SAFETY EVALUATION BY THE OFFICE OF NUCLEAR REACTOR REGULATION
RELATED TO AMENDMENT NO. 68 TO FACILITY OPERATING LICENSE NO. DPR-31
AND AMENDMENT NO. 60 TO FACILITY OPERATING LICENSE NO. DPR-41

TURKEY POINT PLANT UNIT NOS. 3 AND 4

UNITED STATES NUCLEAR REGULATORY COMMISSIONDOCKET NOS. 50-250 AND 50-251FLORIDA POWER AND LIGHT COMPANYNOTICE OF ISSUANCE OF AMENDMENT TO FACILITY
OPERATING LICENSES

ATTACHMENT TO LICENSE AMENDMENTS

HOT CHANNEL FACTOR
NORMALIZED OPERATING ENVELOPE

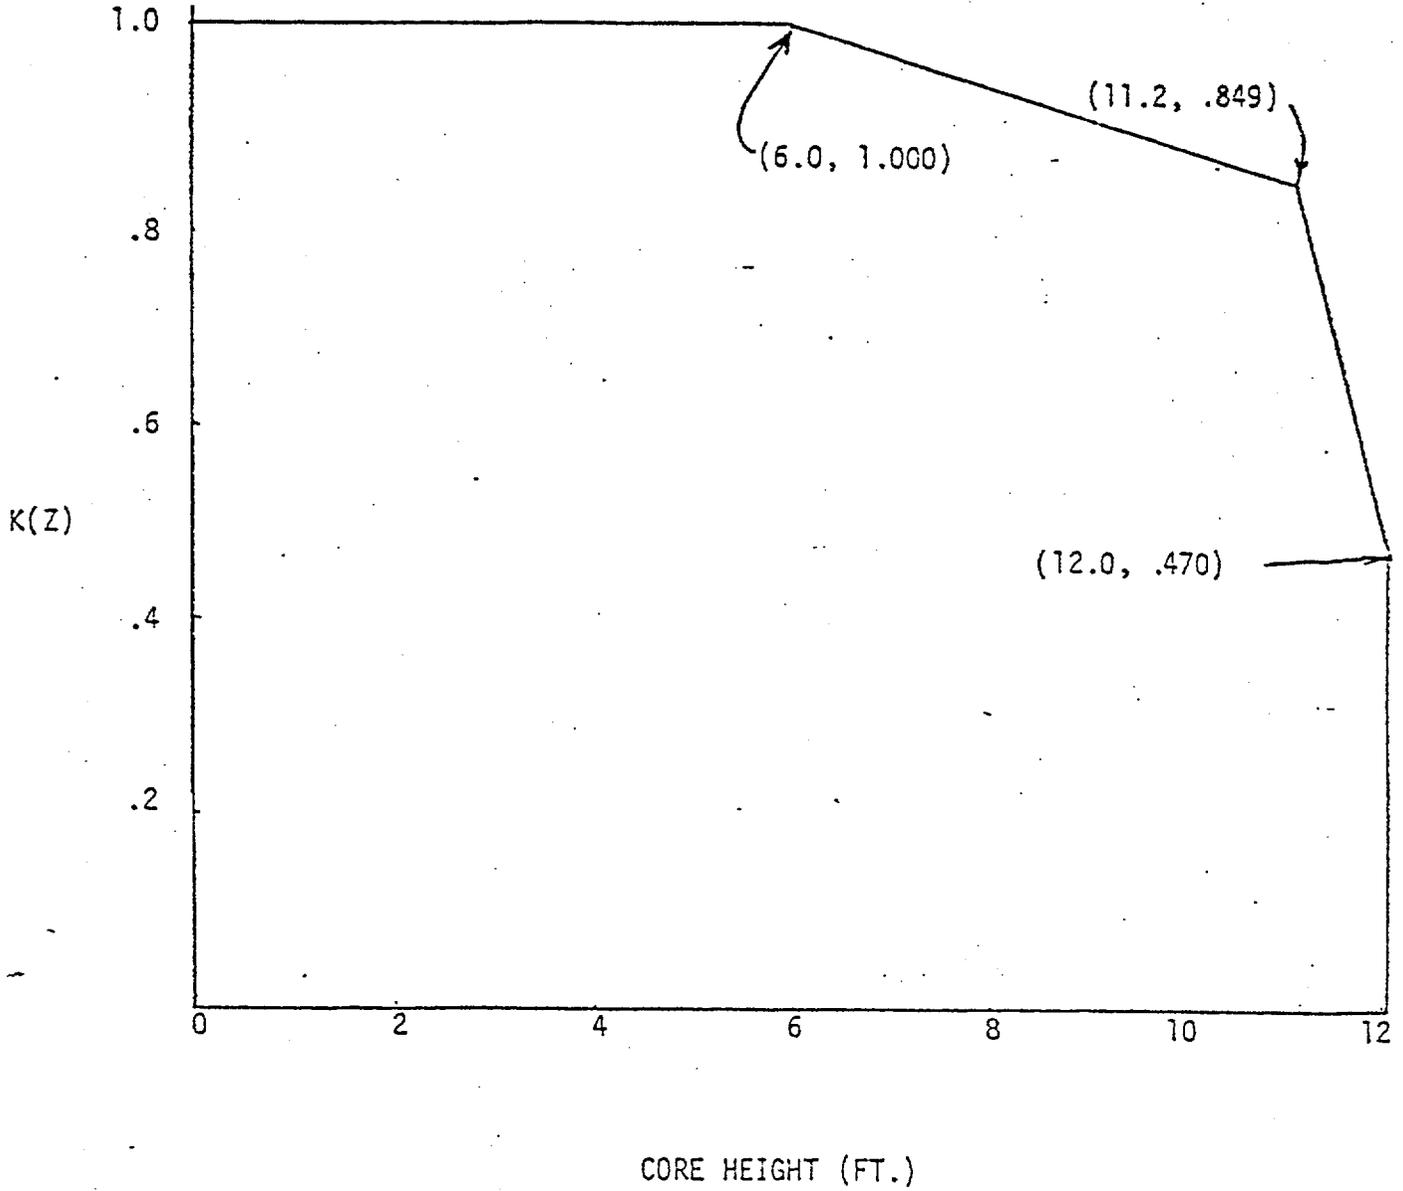
f. Figure 3-2-3

The $K(Z)$ curve has been modified to reflect the new steam generator tube plugging limit and new F_Q .

(for $\leq 28\%$ steam generator tube plugging and $F_q = 2.125$)

FIG. 2.1-16

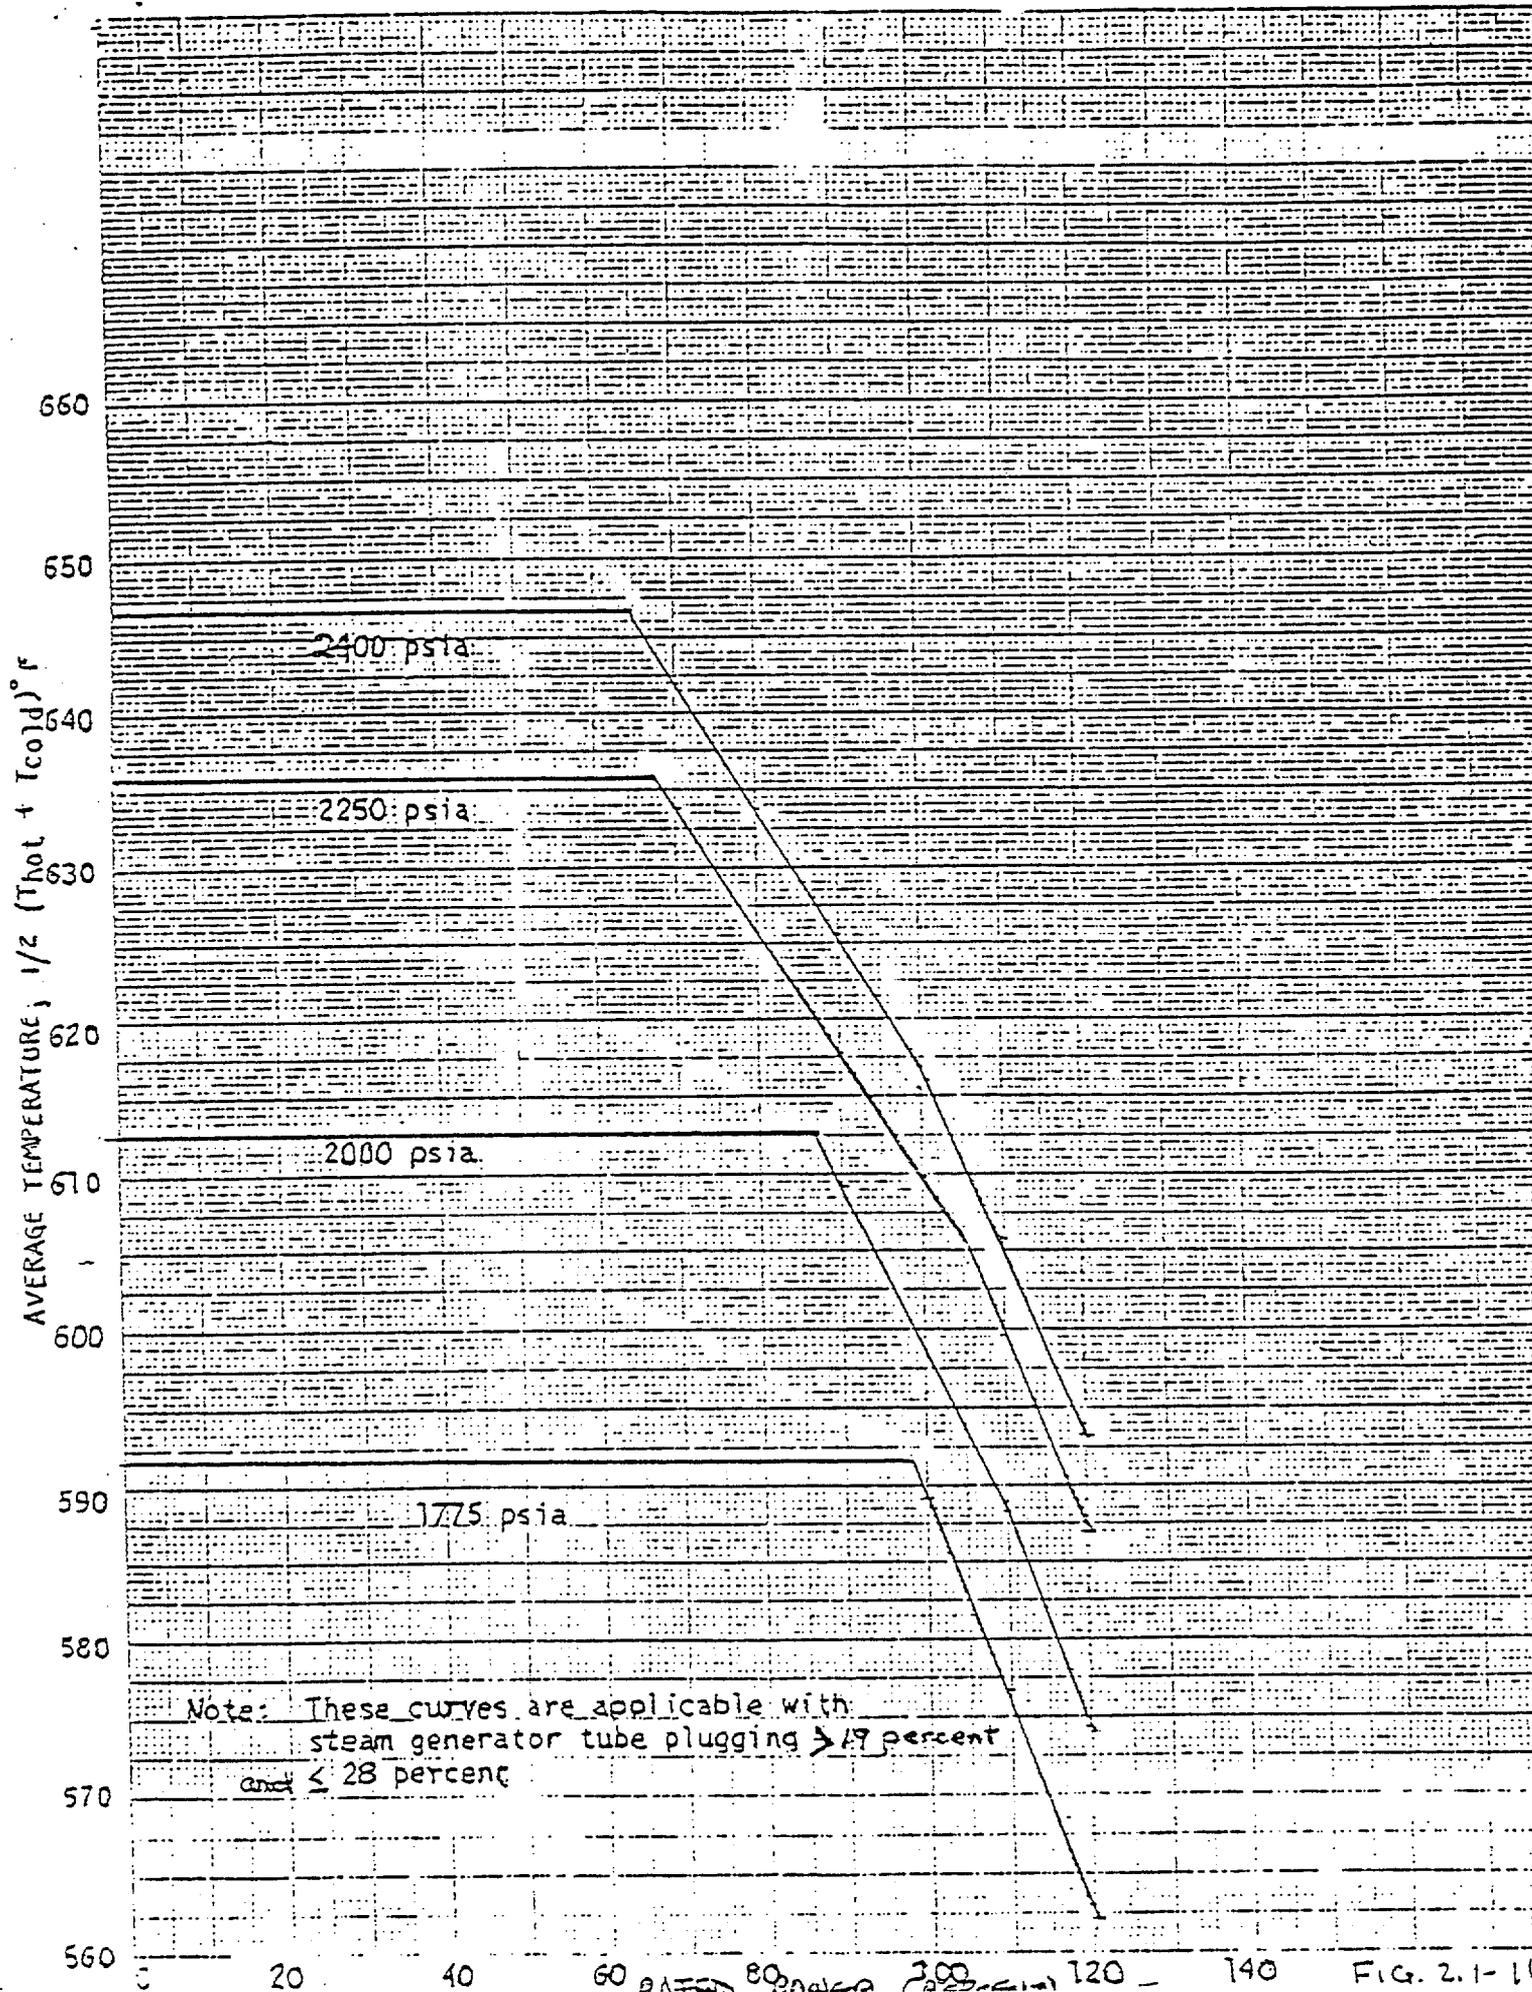
a. Figure 2.1-1b

The curve has been updated to reflect the new steam generator tube plugging limit, and has been corrected per our NSSS vendor's recommendation.

REACTOR CORE THERMAL AND HYDRAULIC SAFETY LIMITS,
THREE LOOP OPERATION
